Product Change Notification / GBNG-06GBPZ091

CCB 3640 Final Notice: Qualification of MTAI as a new final test site for selected Atmel products available in 20L PLCC package.

CCB 3640
Pre and Post Change Summary
PCN# GBNG-06GBPZ091

PCN #: GBNG-06GBPZ091

TUBE PACKING METHOD - 20L PLCC

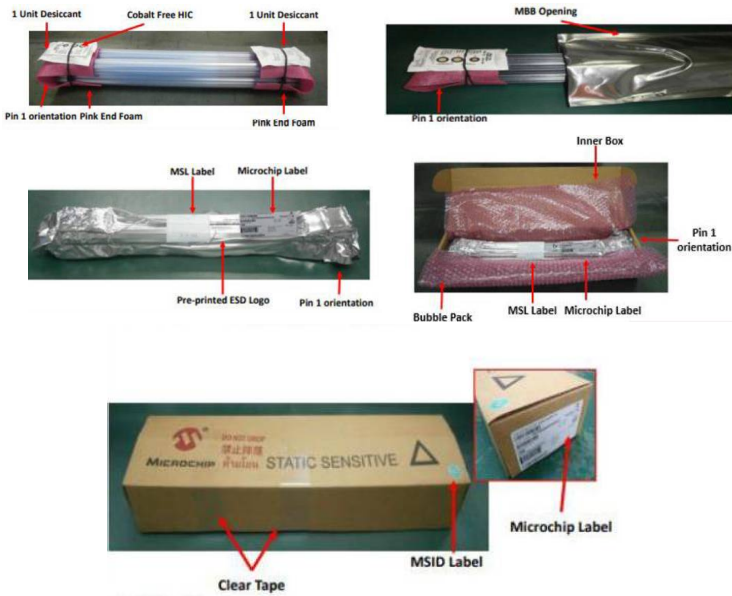
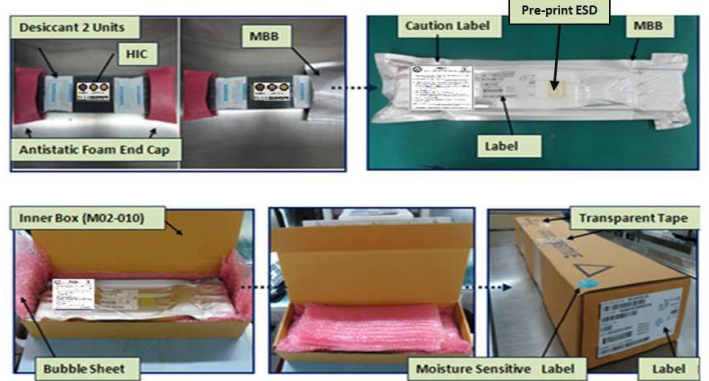
Scan & Pack Site	Tube	Amkor Technology Philippines (P3/P4), INC (ATP7)	Microchip Technology Thailand (HQ) (MTAI)
	Tape & Reel	Microchip Technology Operations (Philippines) Corporation (MPHL)	Microchip Technology Thailand (HQ) (MTAI)
Tube Drawing		No dimensional change. See pre and post change comparison	
Tube Packing Method		See pre and post change comparison.	
Carrier Tape drawing		No dimensional change. See pre and post change comparison	
Cover Tape drawing		No dimensional change. See pre and post change comparison	
Plastic Reel drawing		Minor dimensional change. See pre and post change comparison	
Tape and Reel packing method		See pre and post change comparison.

CARRIER TAPE DRAWING - 20L PLCC

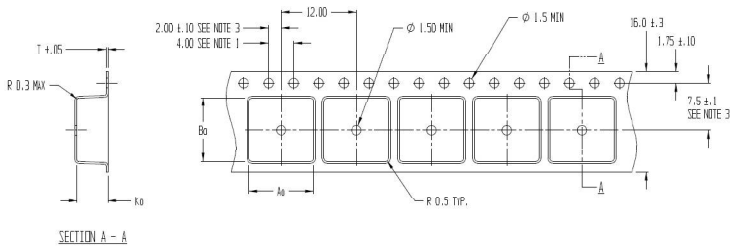
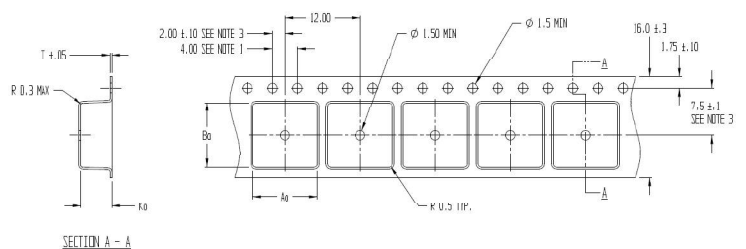
Plant	Supplier Mfg. part no.	Width (mm)	Pitch (mm)	A ₀ (mm)	B ₀ (mm)	K ₀ (mm)	Thickness (mm)	Unit per Reel	Pin Orientation
MPHL	PLCC20-AC	16	12	10.30	10.30	4.90	0.30	1,000	Quadrant 1-2
MTAI	PLCC20-AC	16	12	10.30	10.30	4.90	0.30	1,000	Quadrant 1-2

COVER TAPE DRAWING - 20L PLCC

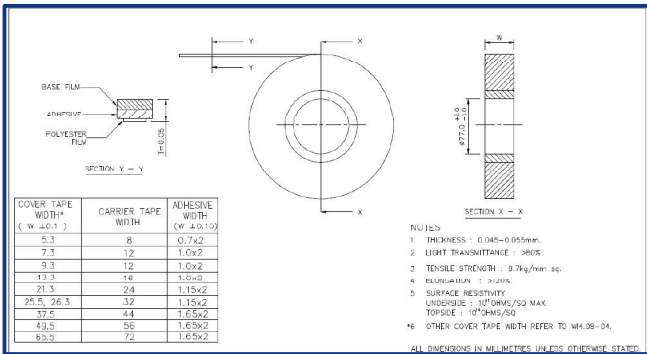
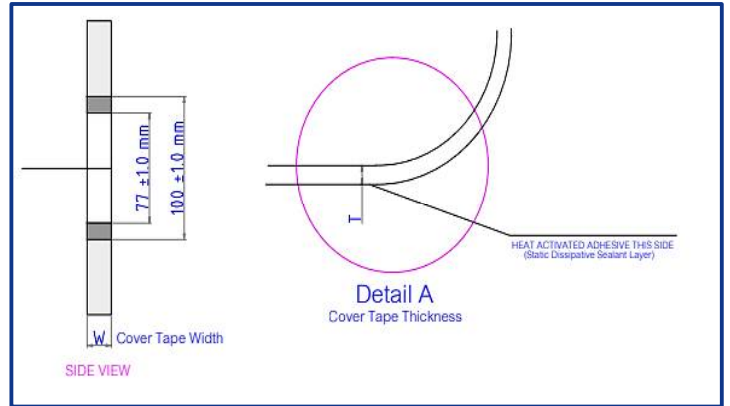
Plant	Supplier Mfg. part no.	Width W (mm)	Thickness "T" (mm)	Color	Sealing Methodology
MPHL	CP58 PSA	13.30 +/-0.1	0.050 +/- 0.010	Clear	Pressure Seal
MTAI	CSL-27302	13.30 +/-0.1	0.050 +/- 0.010	Clear	Heat Seal

PLASTIC REEL DRAWING - 20L PLCC

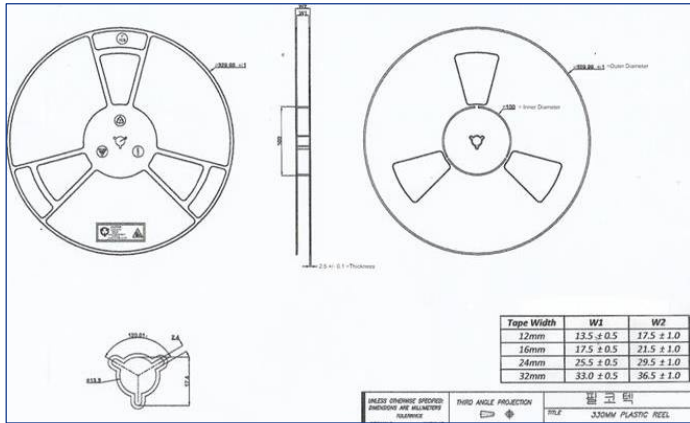
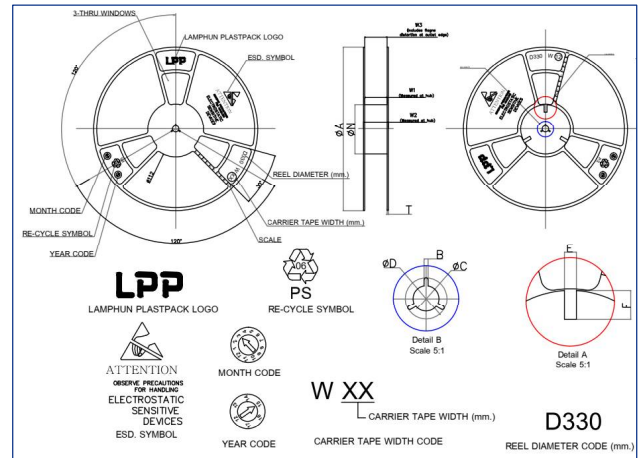
Plant	Reel Diameter (mm)	Reel Hub Size (mm)	W1 (mm)	W2 MAX (mm)	Color
MPHL	330	100	17.50	22.50	White
MTAI	330	100	16.40	22.40	Dark Blue
